Document Number: D10122-A-G0082

Notice of Change to Individual Bag for Connectivity Module

Connrctivity Module Family

Change① Caution Label

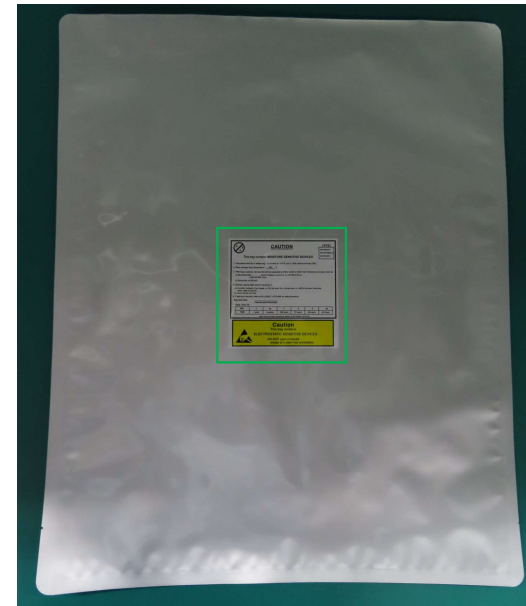
Before :

No label printing

After :

Label printed

Manually sticking a Caution label on the aluminum bag because no Caution label printing before change.

Change① Caution Label

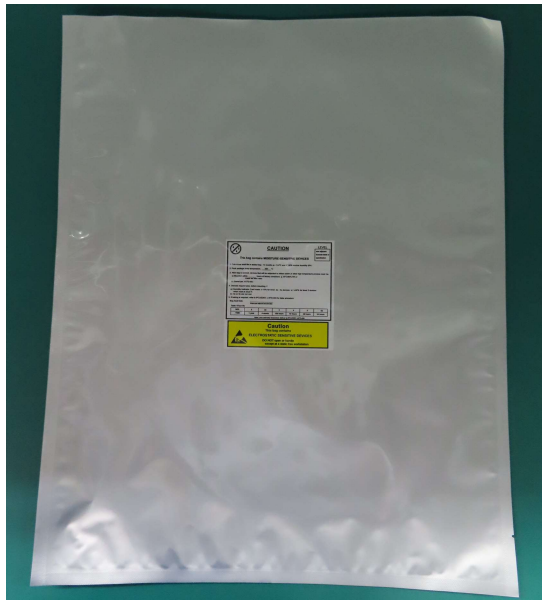
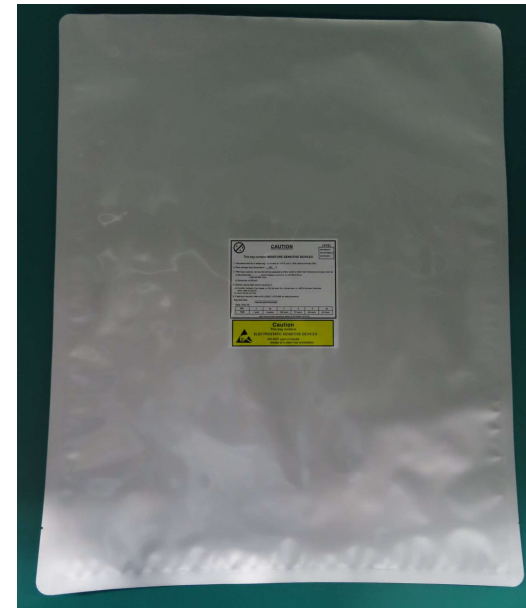
- Comparison of Caution label sticker application and Caution label printing conditions

Before :
Sticking a label

After :
Label printed

Change① Caution Label

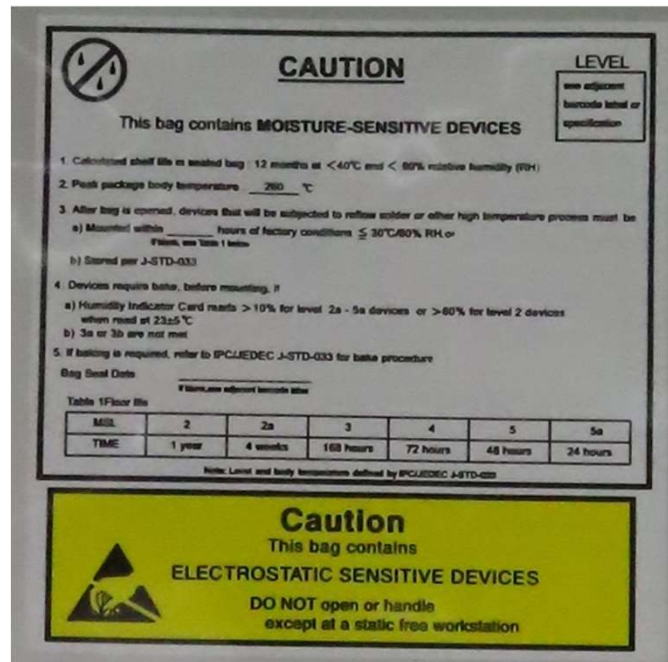
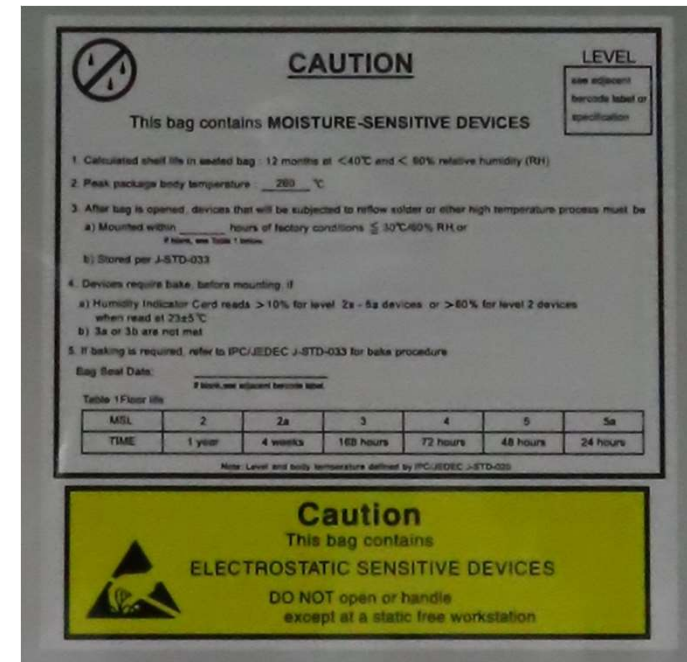
Comparison of Caution label stickers and Caution label printed labels

Before :
Label sticker

After :
Label print

Change② Corners of aluminum bag

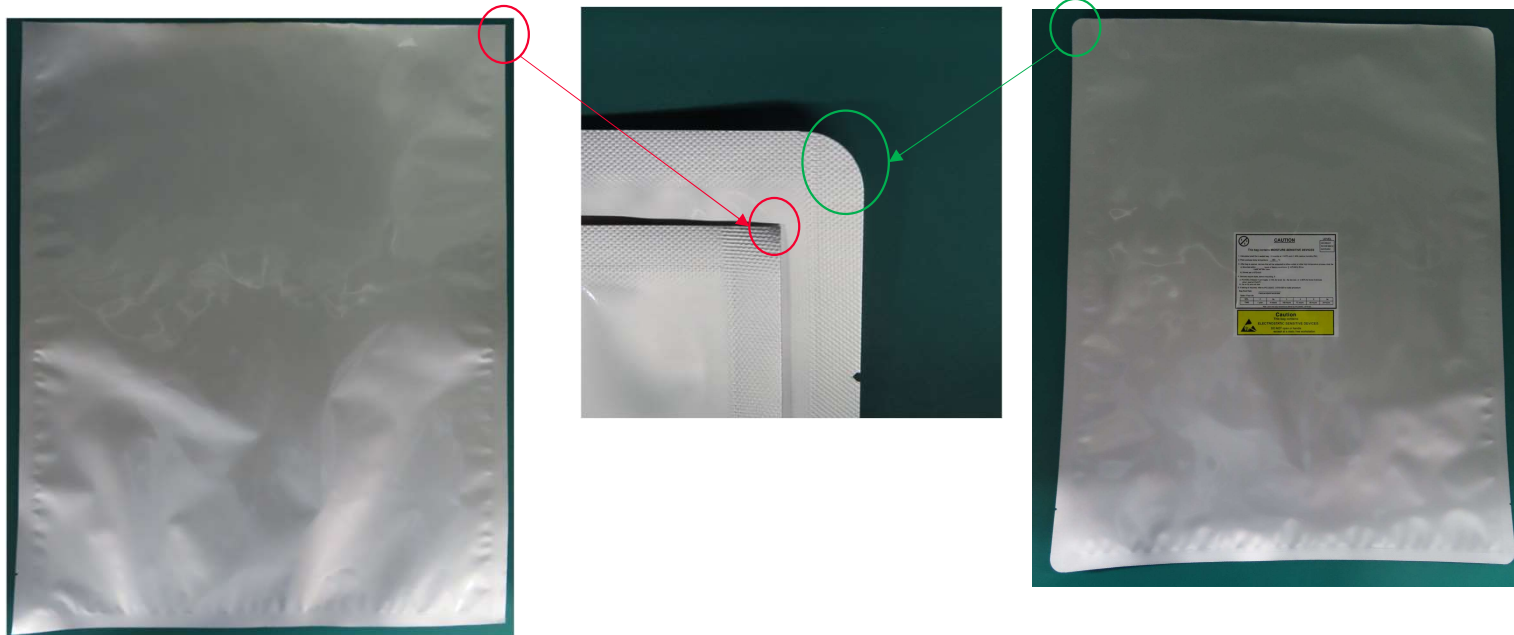
Before :
Right angle

After :
Curved
